**[Darshan\\_04\\_0917.pdf](#) (PSE state machine Part A- Using CLASS\_PROBE in Figure 145-15/16)  
Comment (i-198, i-269, i-406)**

**4. Make the following changes to the state machine in page 132**

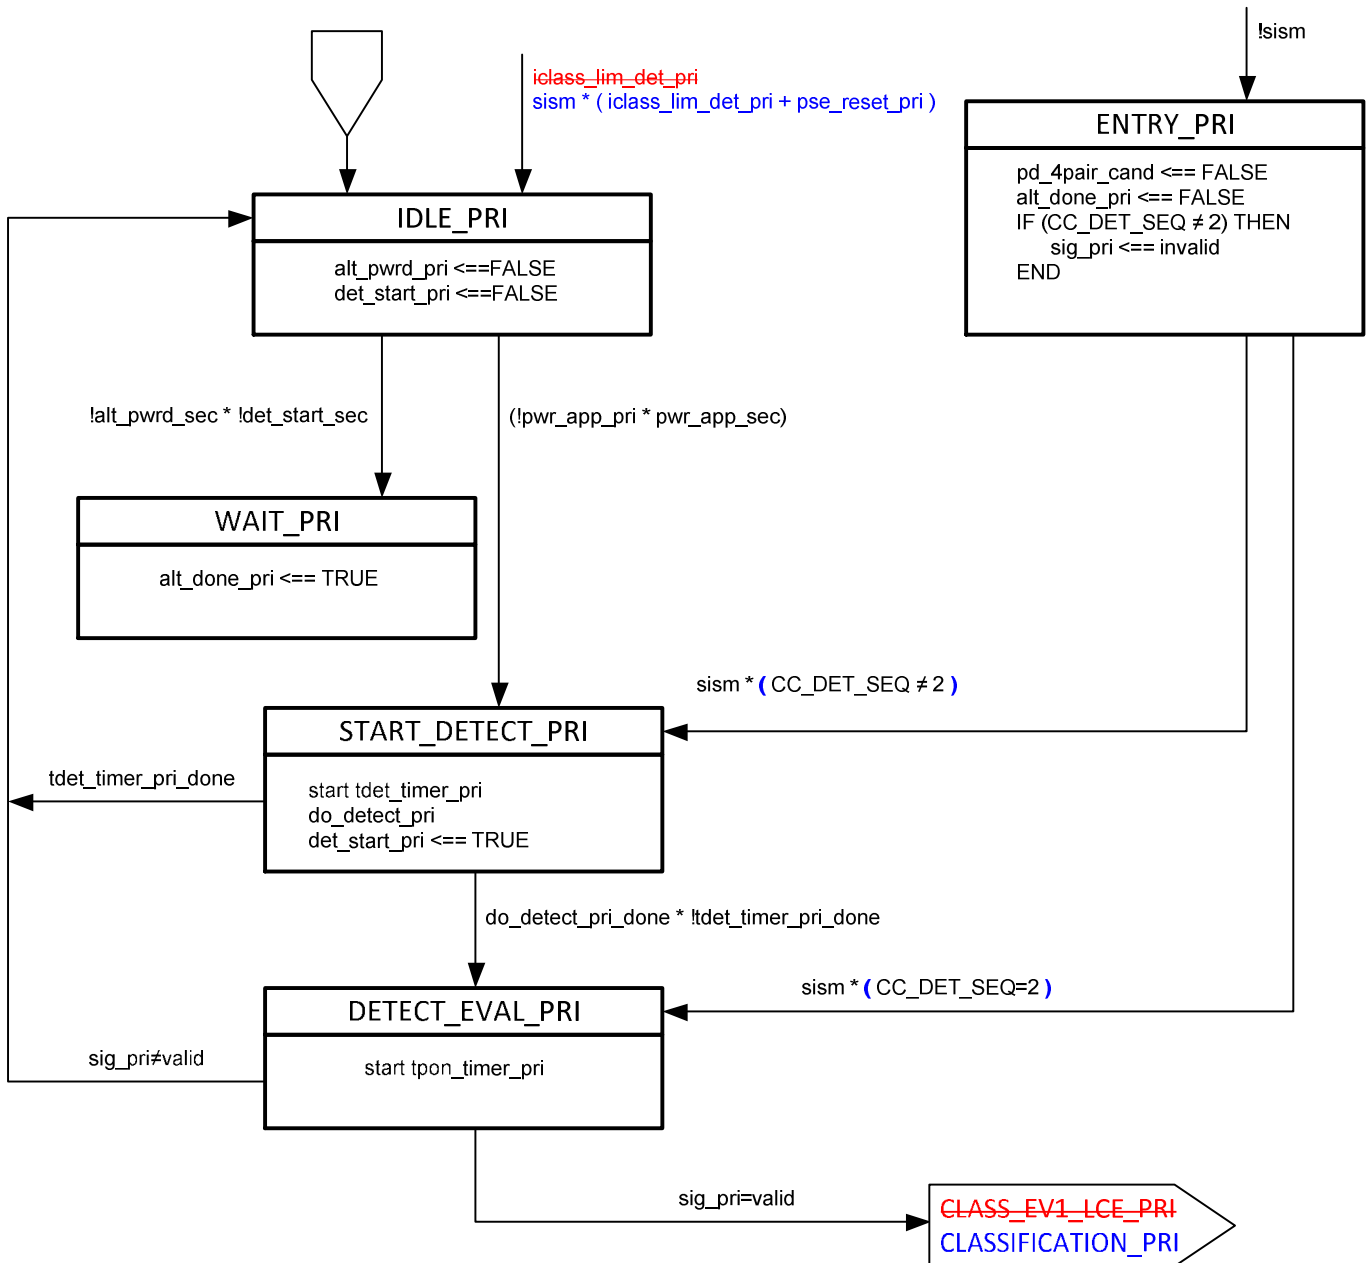
- (1) Add CLASS\_PROBE\_PRI/SEC functionality for primary and secondary.
- (2) Add global exit to IDLE\_PRI/SEC by using pse\_reset\_pri/sec by changing the input to IDLE\_PRI to  $\text{sism}^*(\text{iclass\_lim\_det\_pri} + \text{pse\_reset\_pri})$  it will do two things: pse\_reset\_pri and multi-true issue with IDLE\_PRI and ENTRY\_PRI. To implement same changes for secondary.

Figure 145-15—Primary Alternative dual-signature semi-independent PSE state diagram (continued)

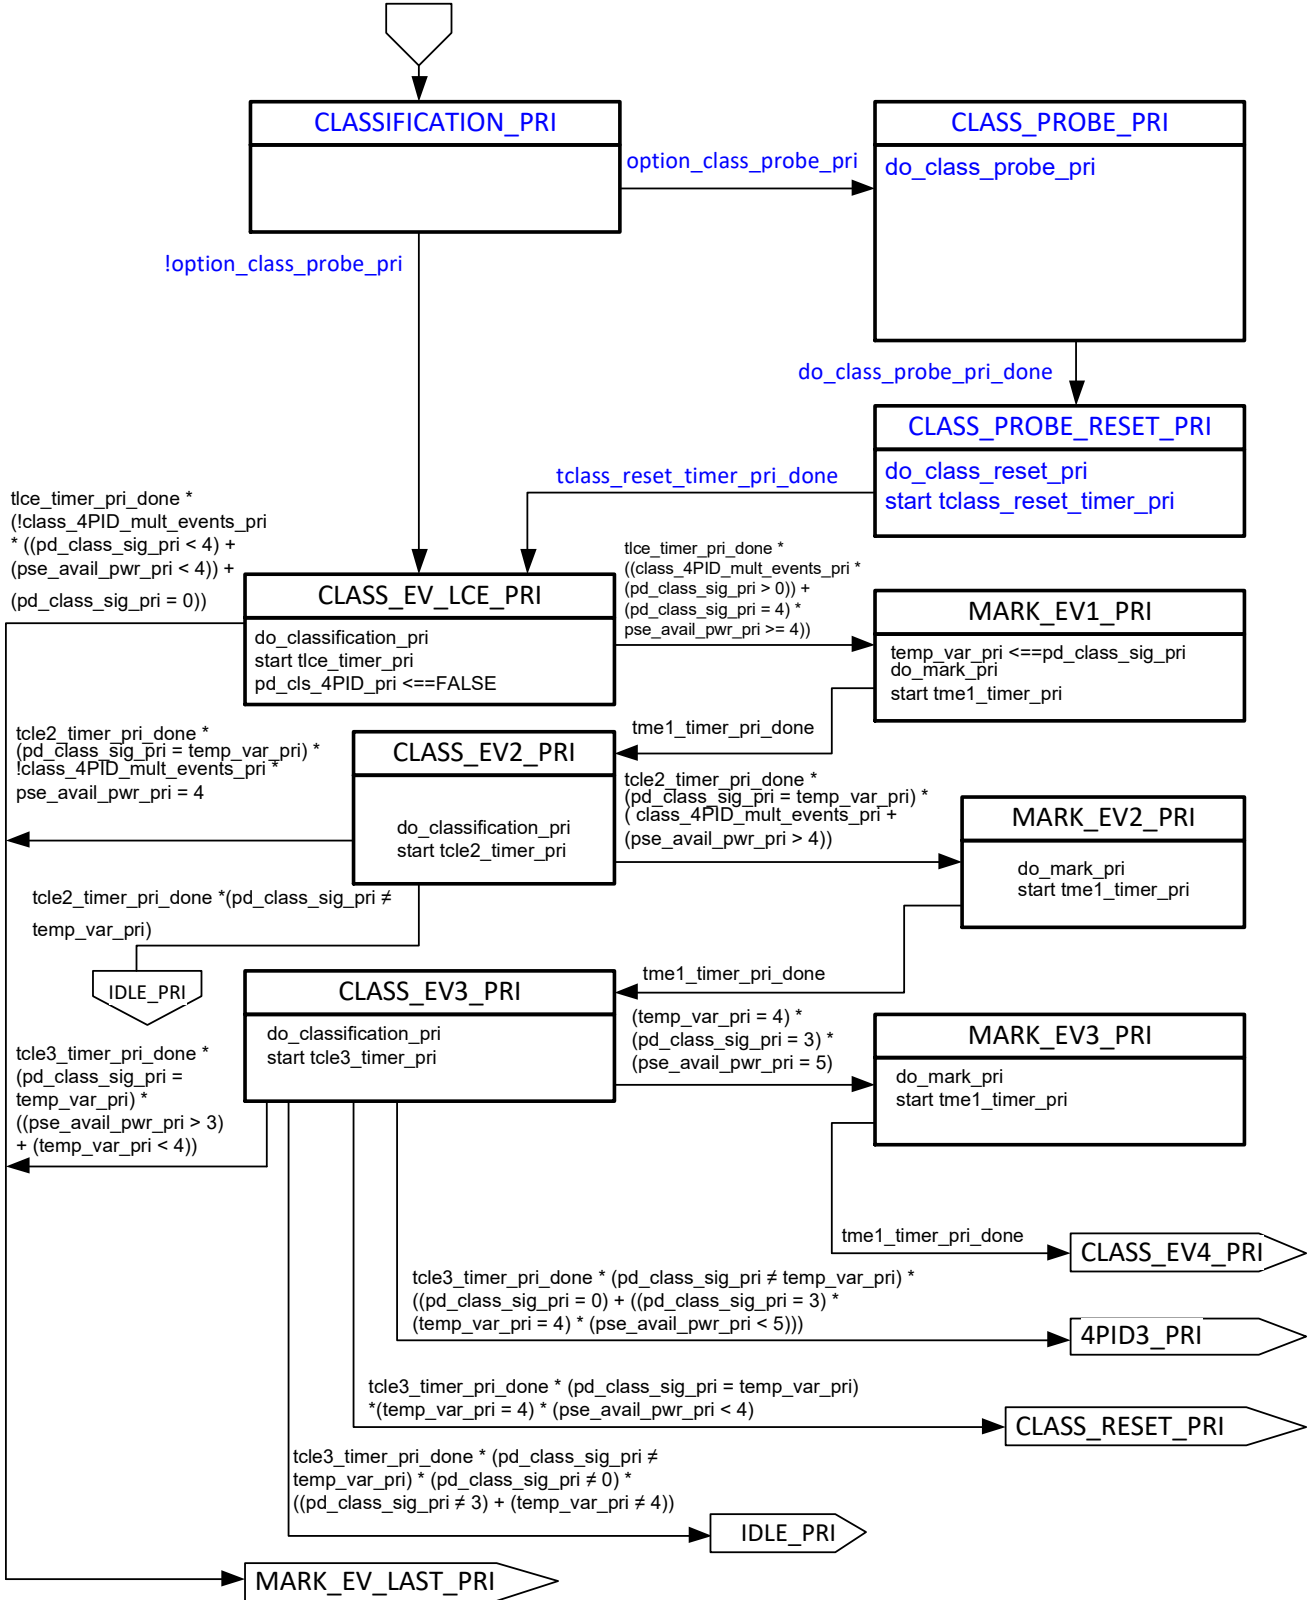
5. Make the following changes to Figure 145-15 page 133

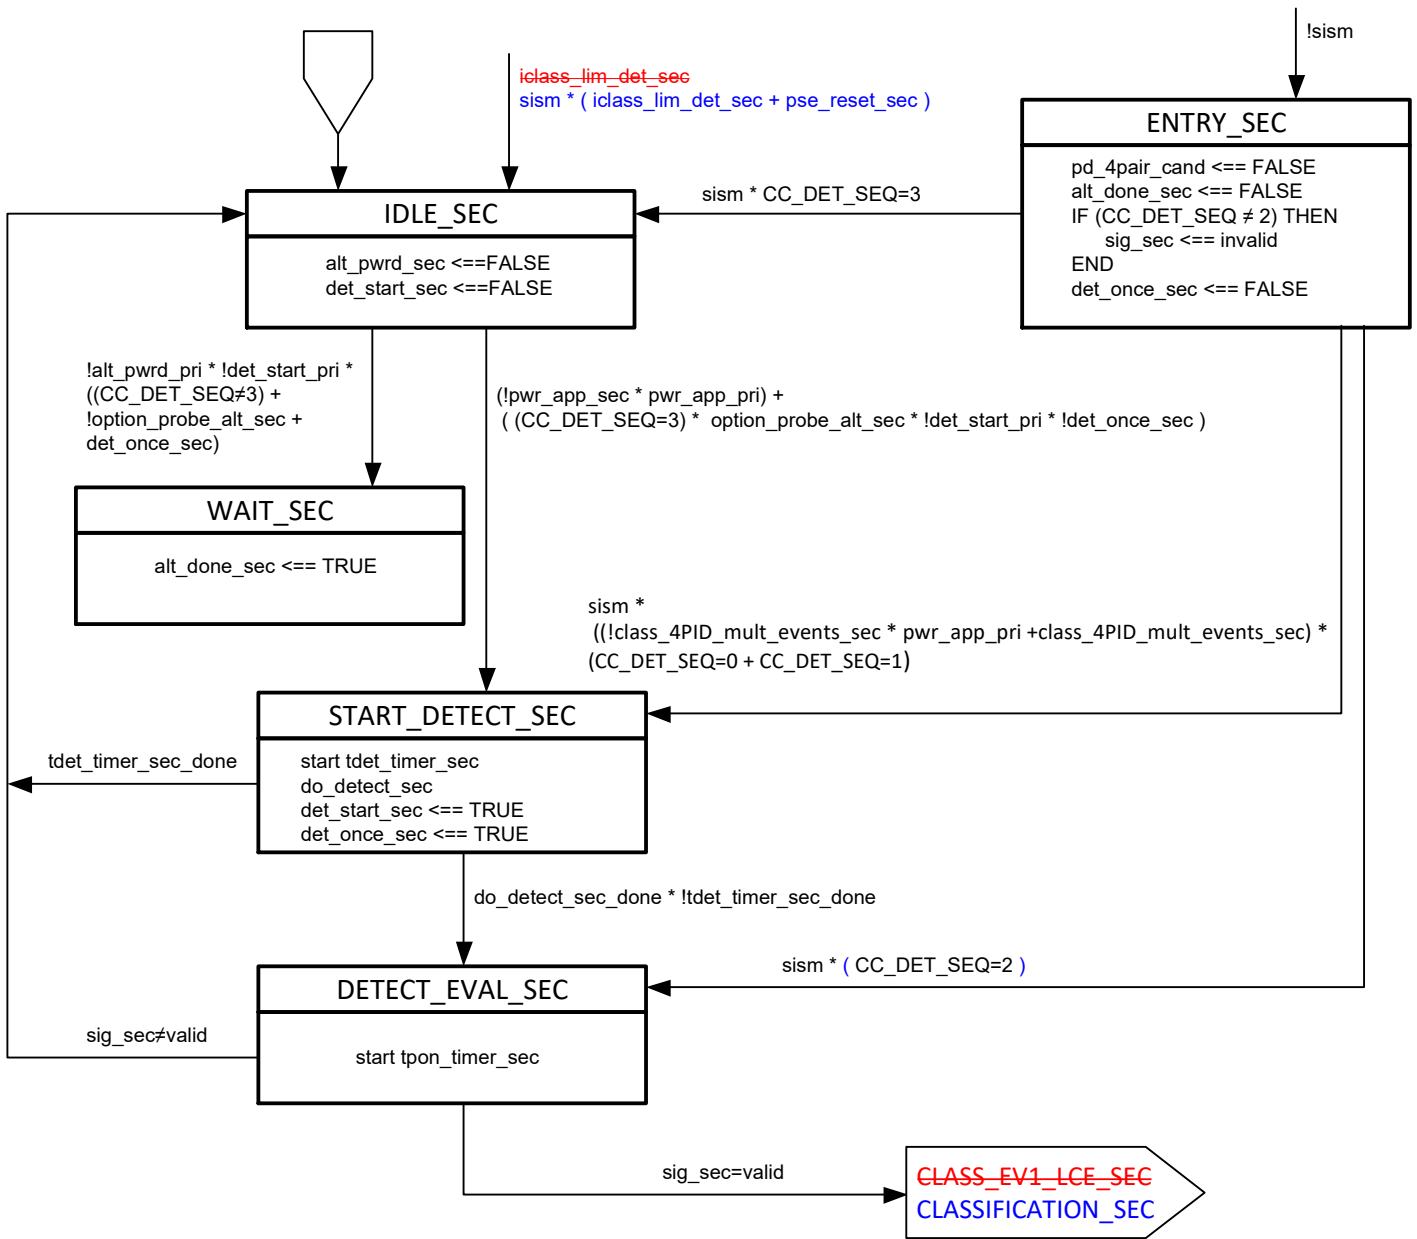
6. Make the following changes to the state machine in page 136

Figure 145-15—Primary Alternative dual-signature semi-independent PSE state diagram (continued)

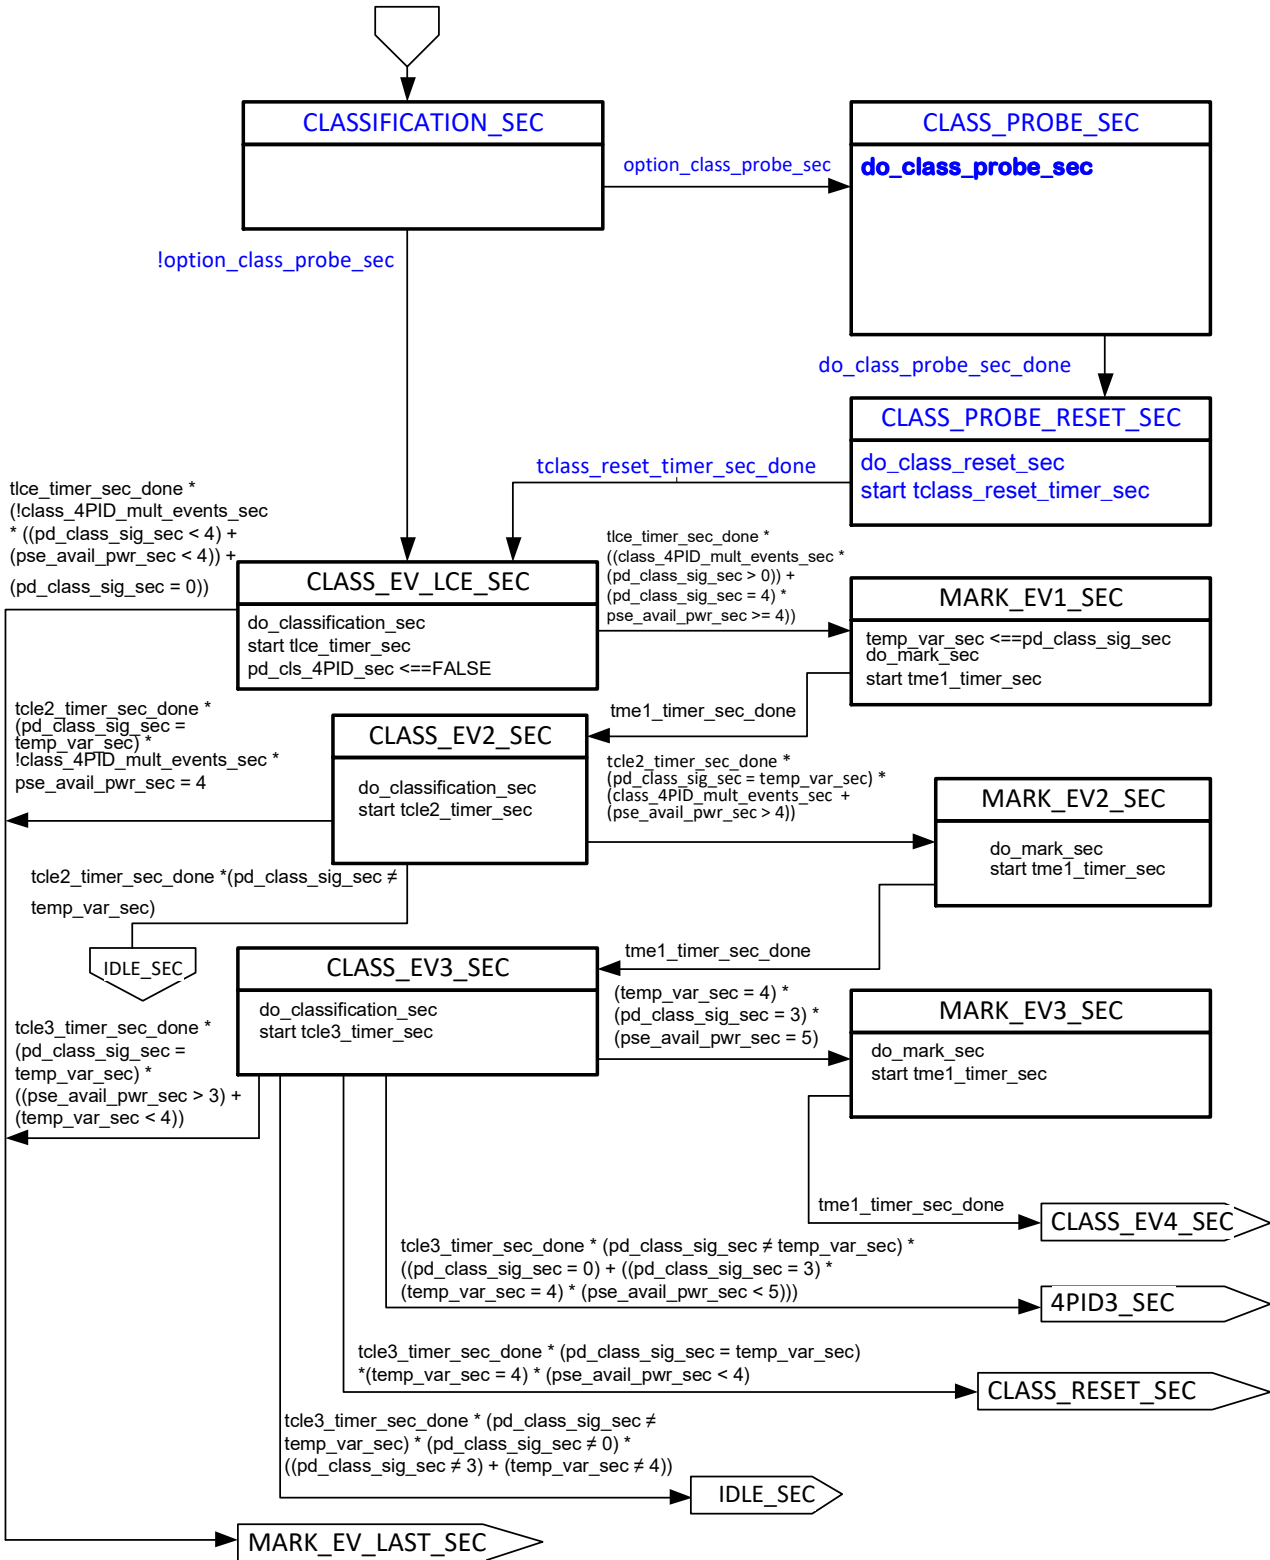
7. Make the following changes to Figure 145-15 pages 137
